ALERT SERVICE BULLETIN

NO. 407-09-89

MODEL AFFECTED: 407

SUBJECT: TAIL ROTOR GEARBOX P/N 406-040-400-ALL AND TAIL ROTOR GEARBOX CASE ASSEMBLY P/N 406-040-406-ALL, ONE TIME INSPECTION OF.

Figure 1. Studs and dowel pins location

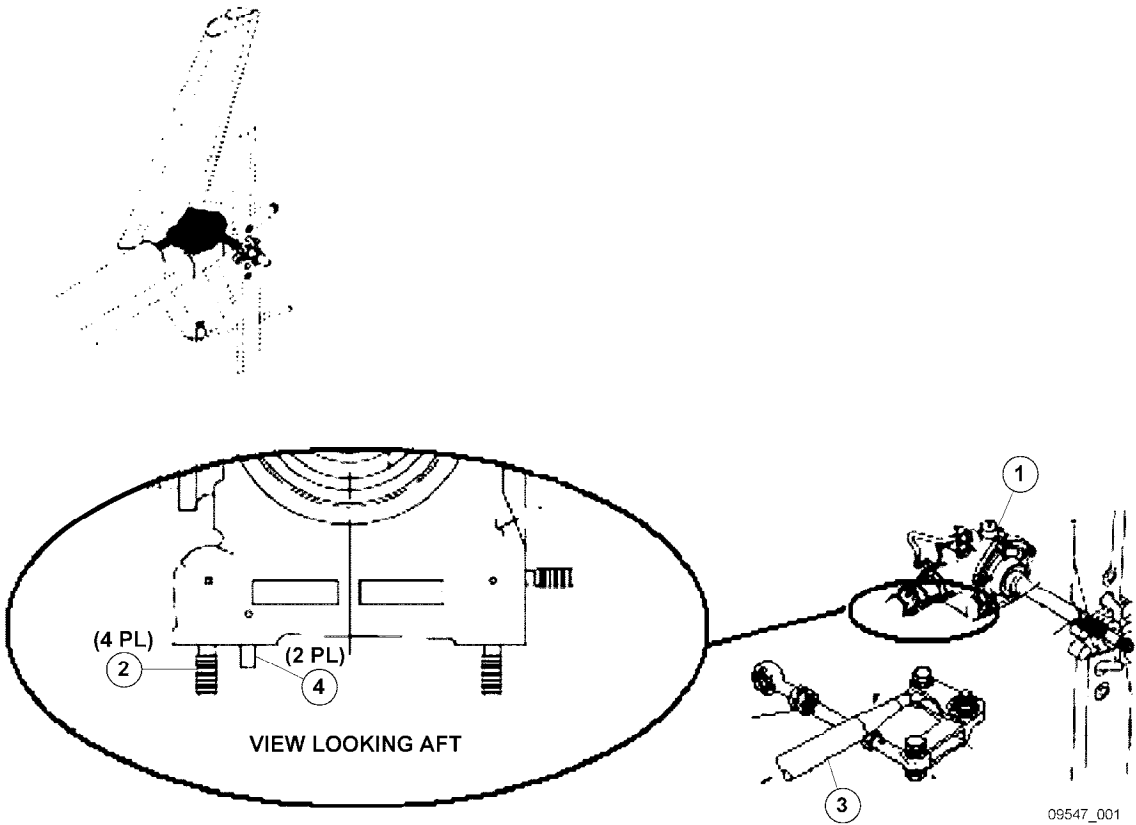
Bell Helicopter has received reports of tail rotor gearbox assembly found with mounting studs incorrectly installed. This condition could lead to low clearance or fouling condition between the forward right hand stud and the aft end upper surface of the tail rotor control tube assembly 407-001-026 (long tube). Reports of dislodged or missing dowel pin in the gearbox case were also received.

1. Inspect the installation of the four tail rotor gearbox assembly and/or case assembly mounting studs (2, Figure 1). Measure all four studs for proper length (BHT-407-CR&O, Chapter 65).

4. Inspect the installation of the two dowel pins (4). Inspect the tail rotor gearbox assembly and/or case assembly to insure that the two dowel pins are properly installed and have not become dislodged from the tail rotor gearbox assembly and/or case assembly.

1. Open the inspection door of the tail rotor gearbox lower fairing (BHT-407-MM, Chapter 53).
2. Using a flashlight and inspection mirror gain visual access to the right hand forward stud (2, Figure 1) and look for evidence of fouling with the directional control tube (3).

1. Remove the tail rotor gearbox fairings (BHT-407-MM, Chapter 53).
2. Using a flashlight and inspection mirror, inspect all four of the tail rotor gearbox mounting studs (2, Figure 1) to ensure that no more than four threads of the stud extend beyond the end of the attaching nut.
3. If more than four threads are exposed beyond the attaching nut on any of the tail rotor gearbox mounting studs (2), remove the tail rotor gearbox (1) and rework the installation of the mounting studs (BHT-407-CR&O, Chapter 65).
4. If less than four threads are exposed beyond the attaching nut on each of the tail rotor gearbox mounting studs (2), proceed to next step.

5. Using a flashlight and inspection mirror, inspect the tail rotor gearbox (1) for proper installation of the two dowel pins (4).
6. If either of the two dowel pins (4) are missing or have become dislodged, remove the tail rotor gearbox assembly (1) and rework the installation of the dowel pins (4) (BHT-407-CR&O, Chapter 65).
7. If the tail rotor gearbox assembly (1) meets the inspection requirements described in Steps 1 through 6, the tail rotor gearbox assembly (1) is serviceable.
8. Reinstall the tail rotor gearbox fairings (BHT-407-MM, Chapter 53).
9. Annotate the helicopter records indicating compliance with PART III of this bulletin.

2. If the length of any of the four studs is not within limit, rework the installation of the defective stud (BHT-407-CR&O, Chapter 65).
3. If the length of all four studs is within limit, proceed to next step.

5. If either of the two dowel pins are missing or have become dislodged, rework the installation of the dowel pin (4) (BHT-407-CR&O, Chapter 65).
6. If the tail rotor gearbox assembly and/or case assembly meet the inspection requirements described in Steps 1 through 5, the tail rotor gearbox assembly and/or case assembly is serviceable.

3. If the directional control tube (3) shows evidence of fouling with gearbox stud, proceed as follow:
 - a. Remove the tail rotor gearbox fairings and inspect tube for mechanical damage. Refer to the BHT-407-MM, chapter 67. Repair tube assembly in accordance with the BHT-407-MM, chapter 67.

- b. If damage limits are exceeded, discard and replace with a serviceable tube.
 - c. Remove the tail rotor gearbox (1) and accomplish PART I of this bulletin.
